**PLANNED UNIT DEVELOPMENT
& SUBDIVISION STAFF REPORT****Date: July 5, 2012****SUBDIVISION NAME**

AHEPA Subdivision

Planned Unit Development Approval to allow multiple buildings on a single building site and Subdivision approval to create a legal lot of record from four legal lots and a vacated 50-foot right-of-way.

APPLICATION NUMBER 19 & 20 DATE July 5, 2012

SITE PLAN

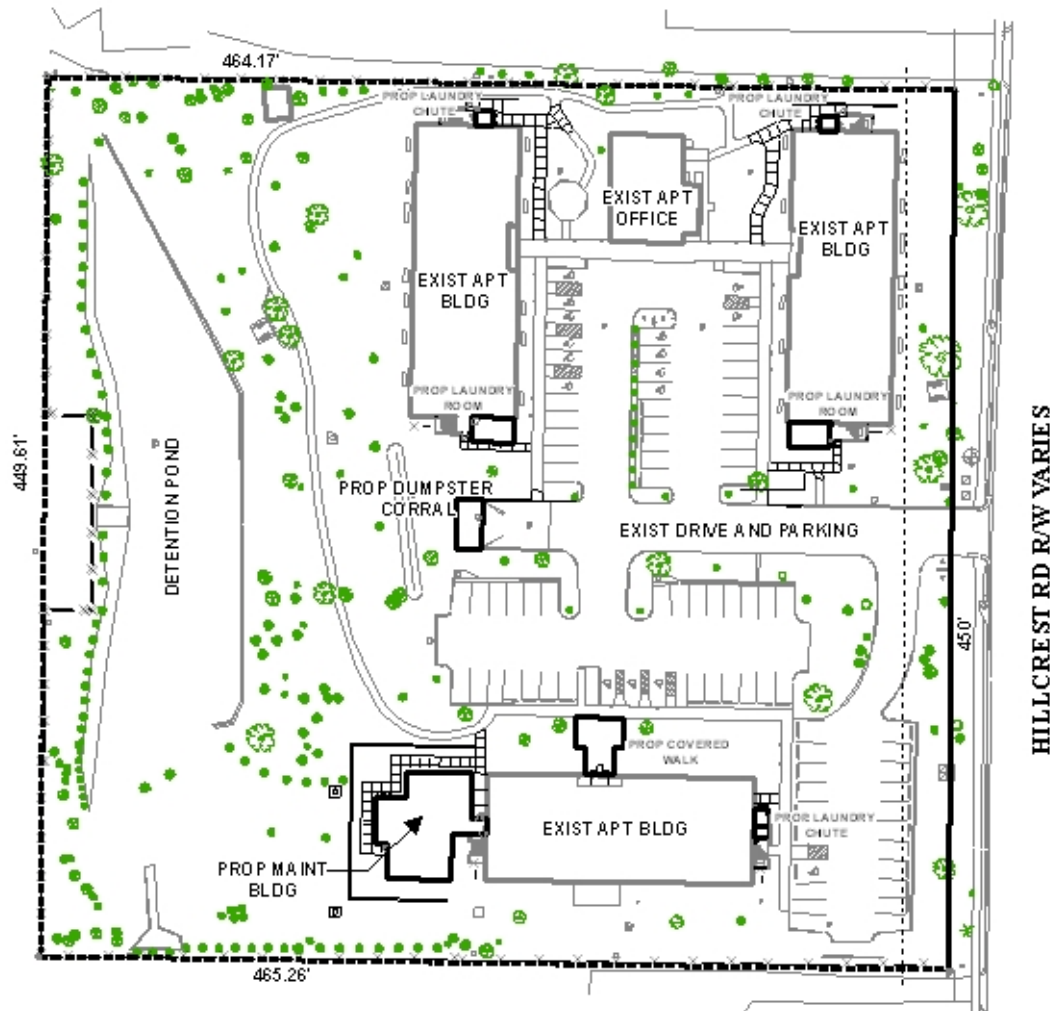
The proposed site plan illustrates three existing buildings with the proposed additions and the relocation of the dumpster corral within the parking area, it should be noted that ALL dumpsters/compactors must meet the buffer requirements of the Zoning Ordinance and be screened with a minimum six-foot solid privacy fence. Also, since the site is adjacent (South and West) to residentially zoned properties, compliance with Section 64-4.D.1., would be required.
